# UNITED STATES PATENT AND TRADEMARK OFFICE

APPLICATION NO.	FILING DATE	FIRST NAMED INVENTOR	ATTORNEY DOCKET NO.	CONFIRMATION NO.
10/737,355	12/16/2003	Brent R. Jones	D/A3075	6010

# Office Action Summary

## DETAILED ACTION

FIG. 4

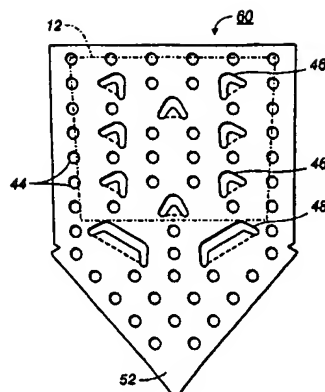
- {claim 1} A drip plate for use in a phase change ink jet printer using solid ink, comprising: an upper portion; and a lower pointed portion, wherein the lower portion is not coplanar with the upper portion (figure 4, reference 46, 52; note that an anchor tab can constitute an upper portion and is not coplanar to lower portion 52)

- {claim 8} wherein the drip plate is made from aluminum (column 7, lines 16-17)
- {claim 12} at least one anchor tab extending from the second side of the drip plate located near the center of the plate (figure 4, reference 46)

- {claim 13} wherein the anchor tabs are arranged in pairs and wherein each pair is arranged substantially symmetrically about a vertical center line (figure 4, reference 46)

- {claim 14} a silver strainer located near a lower edge of the drip plate (figure 4, reference 48)
- {claim 15} An ink loader (figure 3)
- {claim 16} An ink loader for a phase change ink printer (figure 3), comprising: at least one channel having an entry end and an exit end (figure 3, reference 25A-D); a melt assembly, which includes a drip plate including an upper portion having substantially flat upper first and second sides, and a lower portion having substantially flat lower first and second sides, wherein the lower portion is not coplanar with the upper portion (figure 3, reference 60A-D; figure 4, reference 46, 52); a melt plate fastened to the upper second side of the drip plate; and a heating device thermally connected to one of the melt plate and the drip plate (figure 2, reference 27, 29A-D)

- {claim 26} wherein the melt plate includes at least one anchor tab extending from the second side of the drip plate (figure 4, reference 46)
- {claim 27} wherein the melt plate includes a silver strainer located near a lower portion of the drip plate (figure 4, reference 48)

FIG. 3

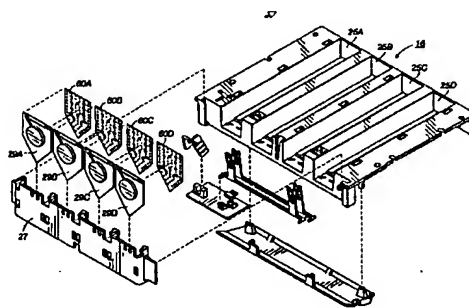
- {claim 2} wherein a heating element is bonded to a first side of the upper portion (figure 3, reference 29A-D)

- {claim 3} wherein the heating element is a closed loop heater (figure 3, reference 29A-D)
- {claim 5} further comprising a bent flange extending upward from the upper side of the drip plate (another one of the anchor tabs can be construed as a bent flange extending upwards)
- {claim 6} wherein the drip plate is made from metal (column 7, lines 16-17)
- {claim 7} wherein the drip plate is made from a nonferrous metal (column 7, lines 16-17)

- {claim 17} further comprising an adapter to position the assembly relative to the at least one channel (figure 3, reference 27)
- {claim 18} wherein at least one of the drip plate and the melt plate is made from nonferrous metal (column 7, lines 16-17)

- {claim 19} wherein at least one of the drip plate and the melt plate is made from aluminum (column 7, lines 16-17)
- {claim 22} wherein the heating element is bonded to the first side of the upper portion of the drip plate (figure 3, reference 29A-D; broad interpretation used of heating element being bonded to drip plate through melt plate)

- {claim 23} wherein the heating element is a closed loop heater (figure 3, reference 29A-D)
- {claim 25} wherein the melt plate has two large cutout portions (figure 2, reference 27; although Jones et al officially calls reference 27 a melt plate adapter assembly, it can be broadly construed as a melt plate in light of the applicant's broad recitation of the claims; note that reference 27 contains numerous holes which can be interpreted as large cutout portions)
